ECE/TRANS/WP.29/2008/81/Corr.1
13 October 2008

Proposal for Supplement 7 to Regulation No. 13-H
(Brakes of M₁ and N₁ vehicles)

Corrigendum

Figure 1. Steering wheel position and yaw velocity information used to assess lateral stability.

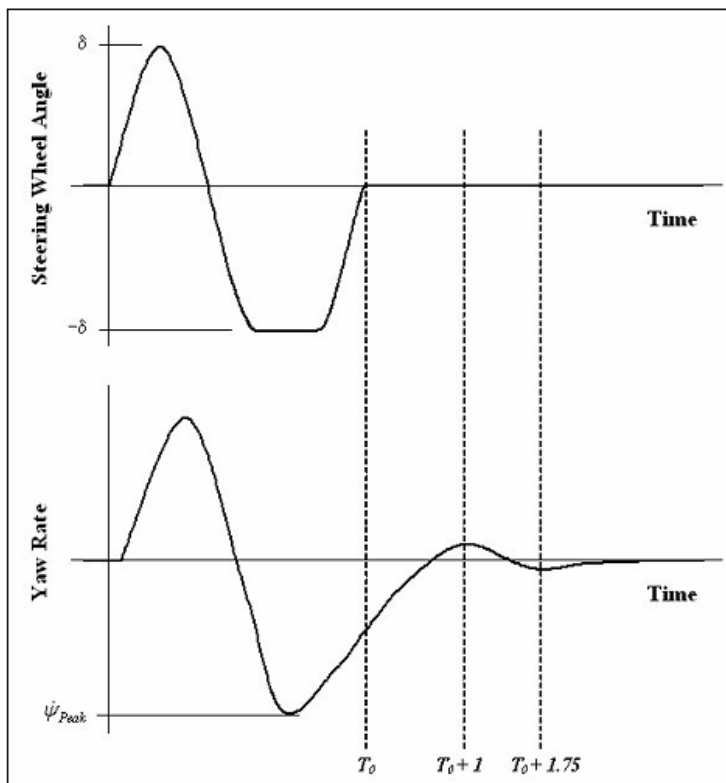
Page 6, paragraph 3.1.

Replace the existing figure by the following one
